Subject: Joint Federal/State Application of Calvert Cliffs 3 Nuclear Project, LLC and UniStar Nuclear Operating Services, LLC, Calvert Cliffs Nuclear Power Plant Site, Lusby, Calvert County, Maryland, USACE Tracking No. NAB-2007-08123-M05

Enclosed please find a response to 13 Questions that were raised during a Multi-Agency site visit at the Calvert Cliffs Nuclear Plant on January 15th and 16th, 2009.

Application NAB-2007-08123-M05
Response to U.S. Army Corps of Engineers Information Request Dated 01/16/09
Calvert Cliffs 3 Project, LLC and UniStar Nuclear Operating Services, LLC
February 12, 2009

FIGURE 4A
 FISH RETURN

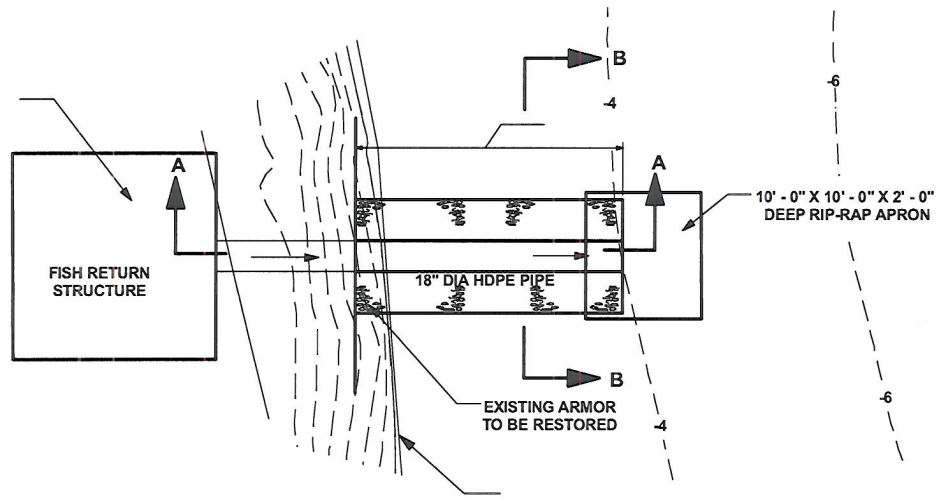
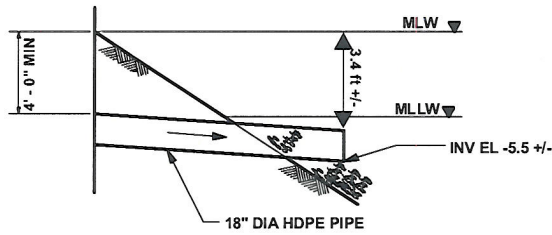
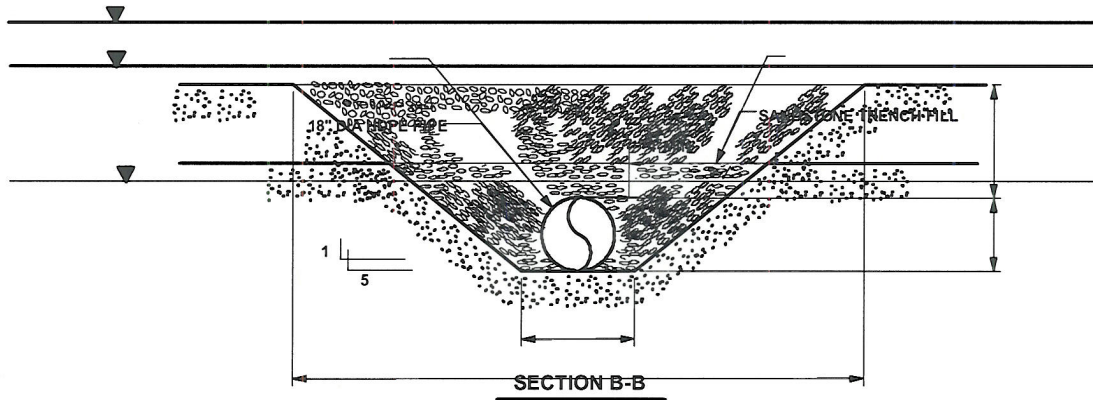
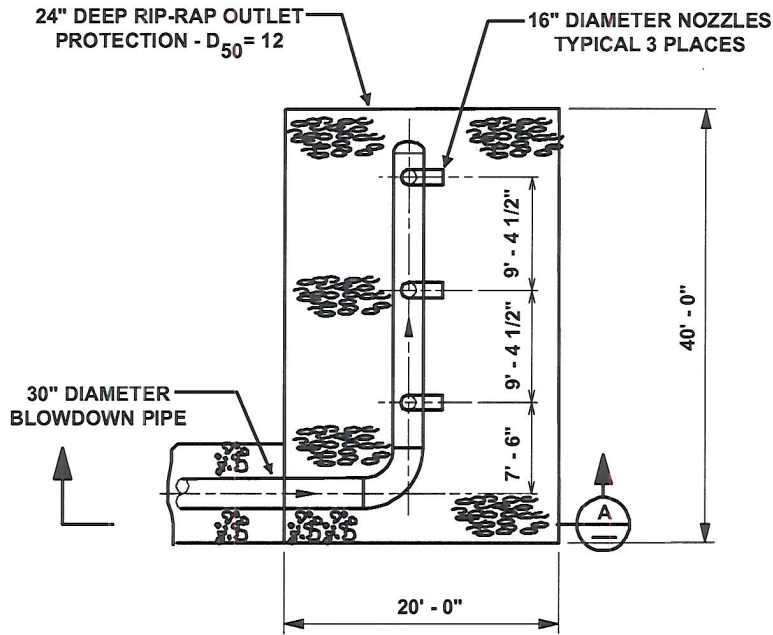
Provide depth from the top of pipe to mean low water for discharge pipe and fish return.

The clearance for the top of the fish return at mean low water is approximately 3.4 ft as noted in Revised Figure 4A (attached). The clearance for the top of the discharge pipe at mean low water is approximately 6.0 ft as noted in Revised Figure 5C (attached). The discharge pipe will be identified by markers as required.

- NOTES: 1. -MEAN HIGH WATERLINE: 0.57'
 -MEAN LOW WATERLINE: -0.60'
 -MAXIMUM SPRING WATERLINE: 1.47'
 -THE DISTANCE FROM THE TOP OF THE FISH RETURN PIPE TO THE MEAN LOW WATER LINE WILL BE APPROXIMATELY 3.4 FT +/-
